## HISTORIC AND DESIGN REVIEW COMMISSION

**HDRC CASE NO:** 2018-254  
**ADDRESS:** 205 OSTROM  
**LEGAL DESCRIPTION:** NCB 6938 BLK LOT 1&2  
**ZONING:** R-4, CD, H, RIO-1  
**CITY COUNCIL DIST.:** 1  
**DISTRICT:** River Road Historic District  
**APPLICANT:** Tobias Stapleton  
**OWNER:** Tobias Stapleton  
**TYPE OF WORK:** Construction of a rear addition and a two story accessory structure  
**APPLICATION RECEIVED:** May 09, 2018  
**60-DAY REVIEW:** July 08, 2018  
**REQUEST:**

1. Construct a rear, two story addition and perform exterior modifications to the primary historic structure.
2. Construct a rear, two story, accessory structure.

Sight Lines  
From Curb

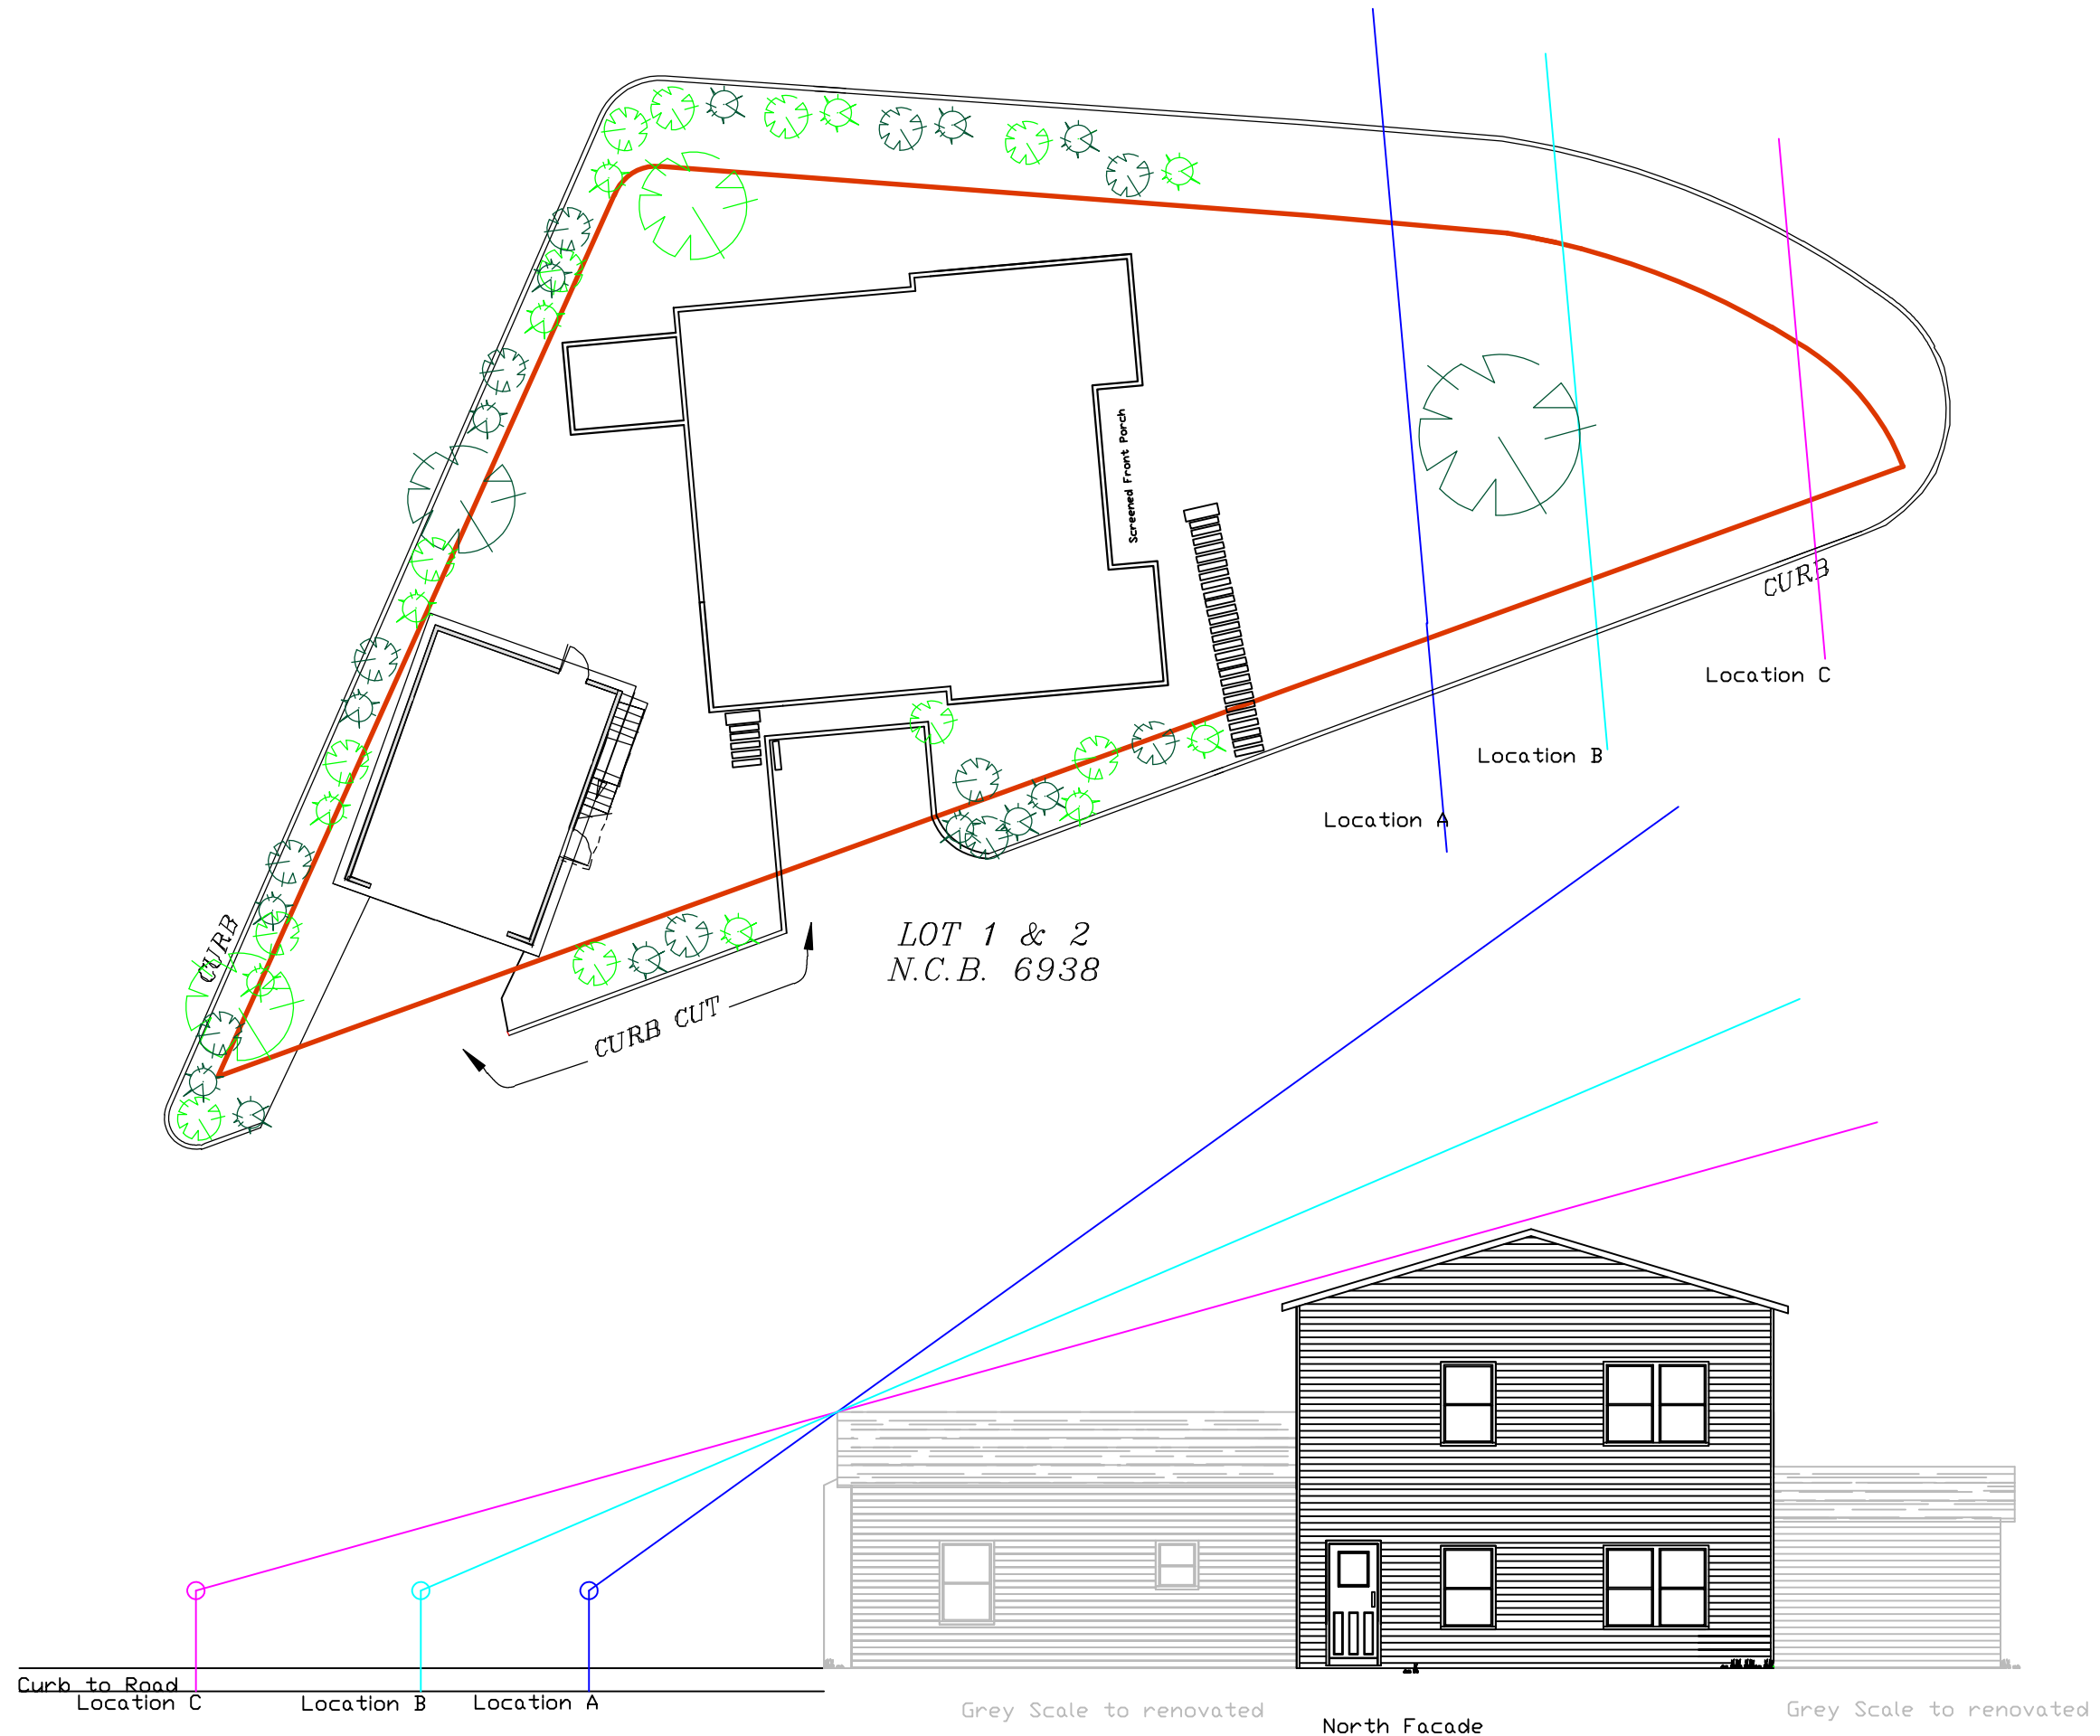
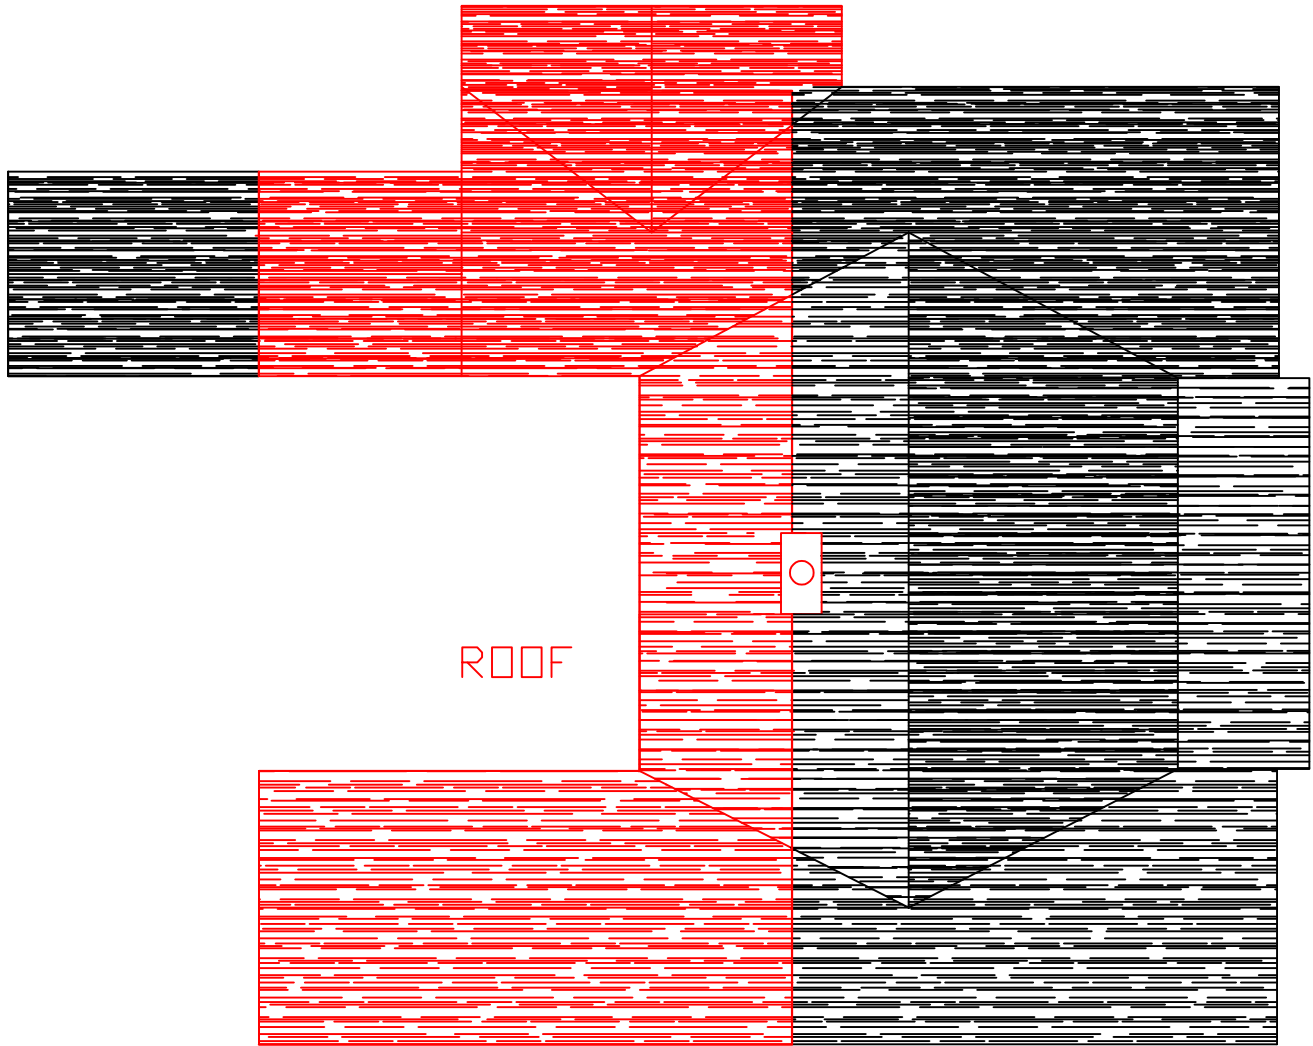
- f. SCALE, MASS & FORM – Regarding scale, mass and form, the applicant has proposed an addition that features two stories in height. While the primary historic structure on the lot features one story in height, the applicant has positioned the proposed addition toward the rear of the lot away from the block face of adjacent streets. Staff finds that the proposed height will not interrupt the block face or perceived massing found along adjacent blocks. The applicant has provided a line of sight diagram providing sight references from various points in front of the primary historic structure.

Issued for Design App  
Accessory Building

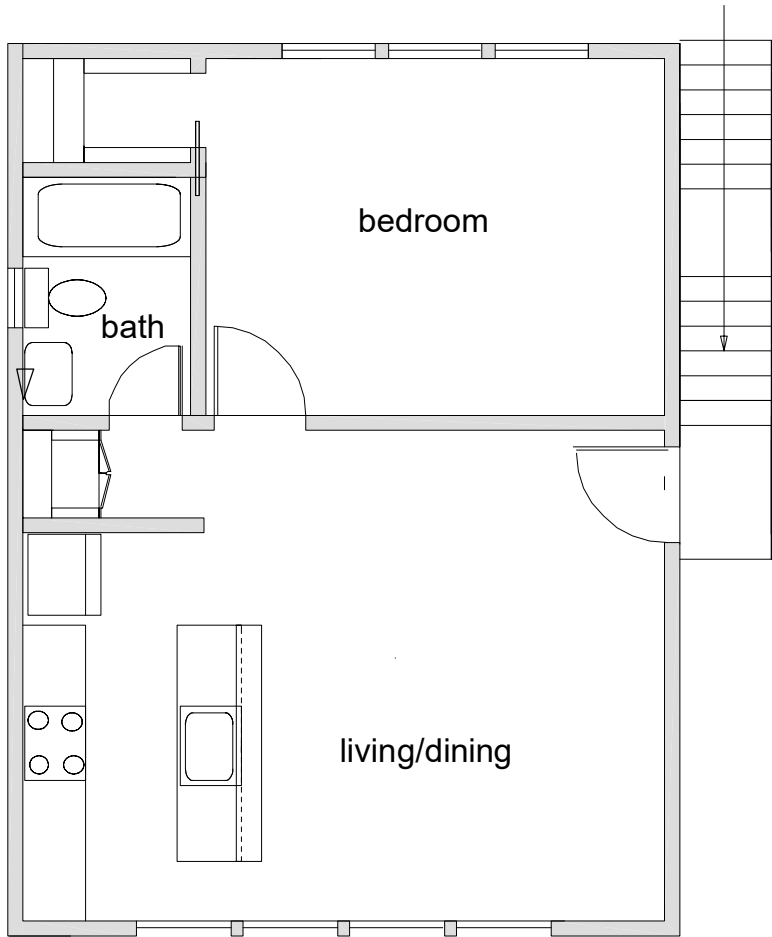
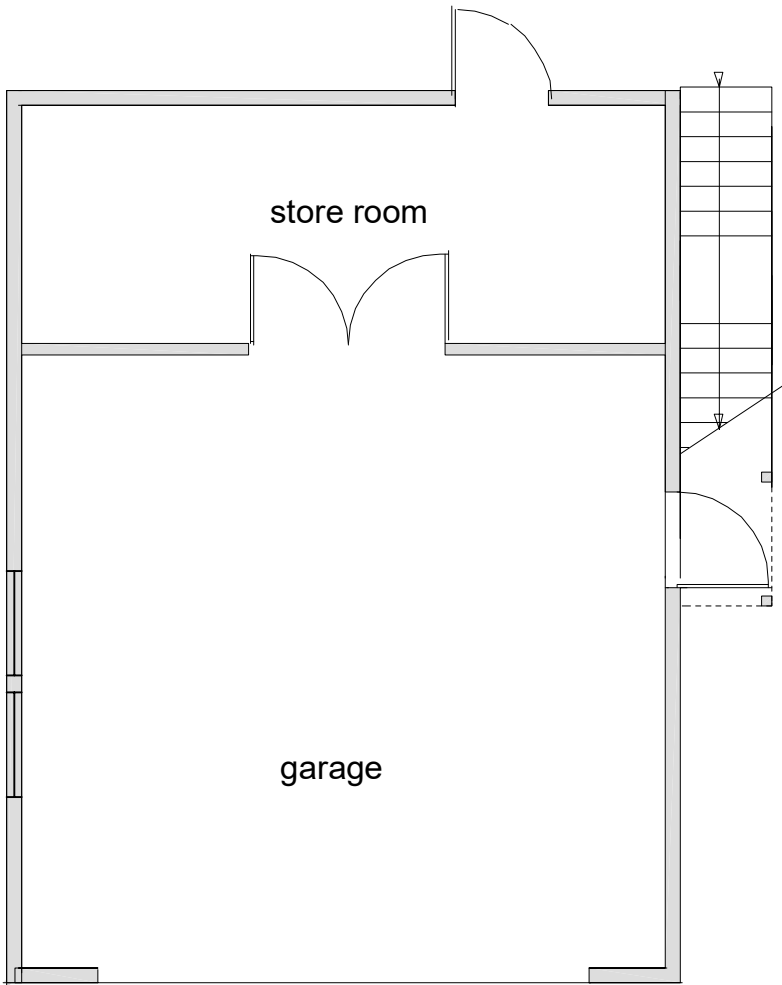
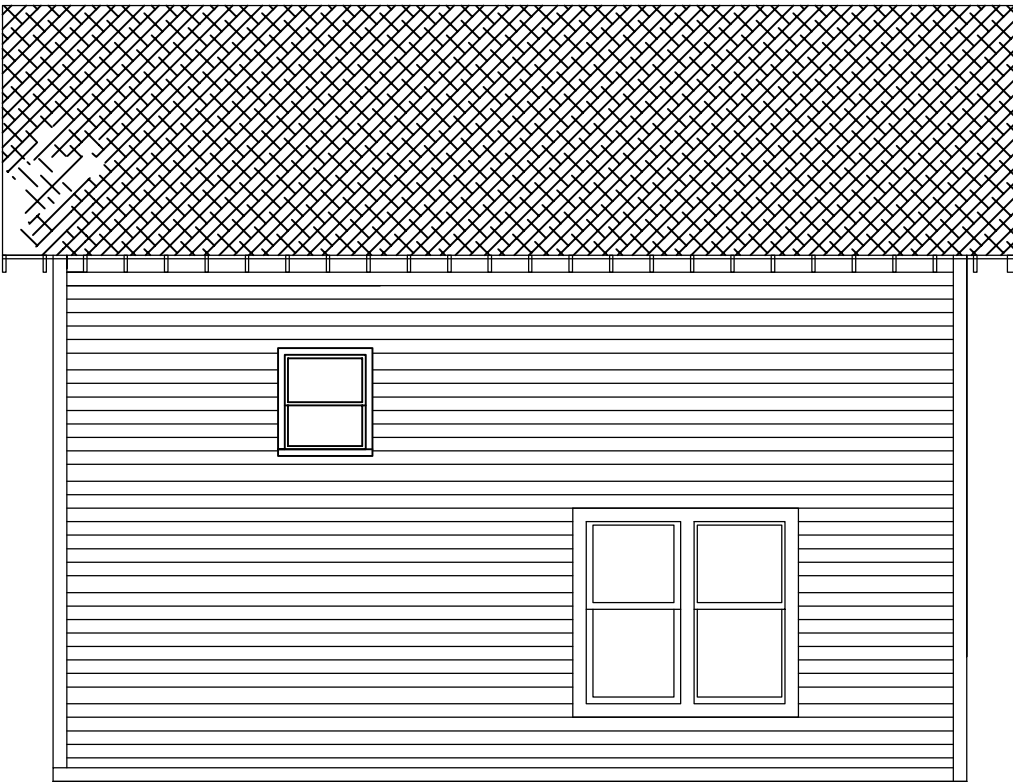
MG: CONCERNS REGARDING PROFILE OF TWO SIDE WINDOWS ON PROPOSED ACCESSORY STRUCTURE; WINDOWS SHOULD FEATURE PROFILE THAT MATCHES THOSE FOUND IN DISTRICT.

NI: CONTINUE TO USE WINDOW PROPORTIONS FOUND ON FRONT OF ACCESSORY THROUGHOUT.

- j. ACCESSORY STRUCTURE – To the west of the primary historic structure, the applicant has proposed to construct a two story, rear accessory structure. The proposed accessory structure feature an overall profile and massing that is subordinate to the proposed addition, features appropriately detailed garage doors and features architectural detailing that’s consistent with the historic examples found throughout the River Road Historic District. Staff finds the proposed accessory structure appropriate and consistent with the Guidelines.

Window Schedule

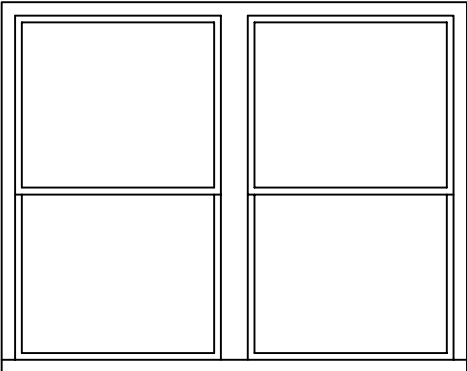
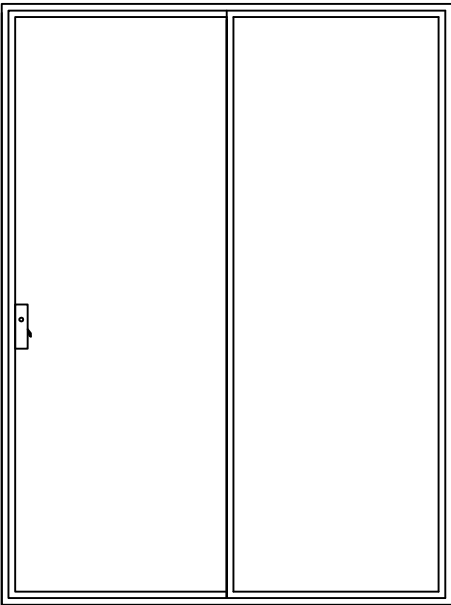
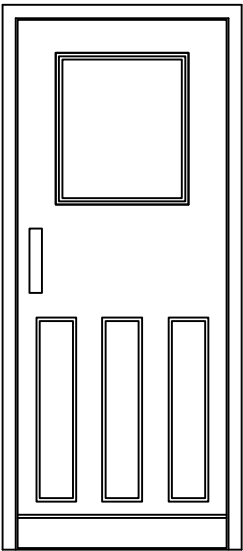
- i. WINDOW MATERIALS – The applicant has noted the use of repaired windows. Regarding new windows, Staff finds that wood or aluminum clad wood windows should be installed that feature meeting rails that are no taller than 1.25” and stiles no wider than 2.25”. White manufacturer’s color is not allowed, and color selection must be presented to staff. There should be a minimum of two inches in depth between the front face of the window trim and the front face of the top window sash. This must be accomplished by recessing the window sufficiently within the opening or with the installation of additional window trim to add thickness. Window trim must feature traditional dimensions and an architecturally appropriate sill detail. Window track components must be painted to match the window trim or concealed by a wood window screen set within the opening.

- i. That the applicant provide additional information regarding new windows when returning for final approval. Staff finds that wood or aluminum clad wood windows should be installed that feature meeting rails that are no taller than 1.25" and stiles no wider than 2.25". White manufacturer's color is not allowed, and color selection must be presented to staff. There should be a minimum of two inches in depth between the front face of the window trim and the front face of the top window sash. This must be accomplished by recessing the window sufficiently within the opening or with the installation of additional window trim to add thickness. Window trim must feature traditional dimensions and an architecturally appropriate sill detail. Window track components must be painted to match the window trim or concealed by a wood window screen set within the opening.
